S E R V I C E N O T E

Agilent 4291B Impedance/Material Analyzer

Serial Numbers: JP1KE00101 / JP1KE00525

Figure 1. AC Inlet Connector

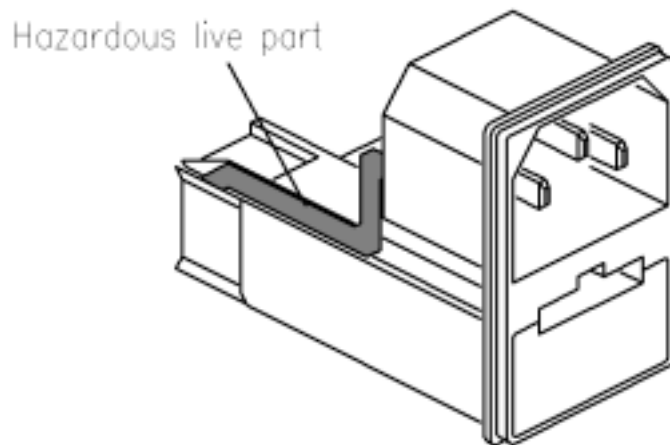
The AC inlet (P/N 1252-6951) has the potential to slip out of the instrument's rear panel slot if the AC power cord is forcefully pulled in a diagonal direction. When this happens, an exposed connection on the AC inlet module may touch the rear panel of the instrument and cause an electrical short if the AC power cord is still connected to the AC power outlet. See Figure 1.

- Remove the AC power cable from the AC power outlet and the product.
- Remove the top, bottom, and side covers.
- Seal the hot line terminal on the AC inlet with silicon paste (P/N 5183-4112).
- Reinforce the connection between the AC inlet and the rear panel with silicon paste.
- Perform Self Test to verify instrument operation.
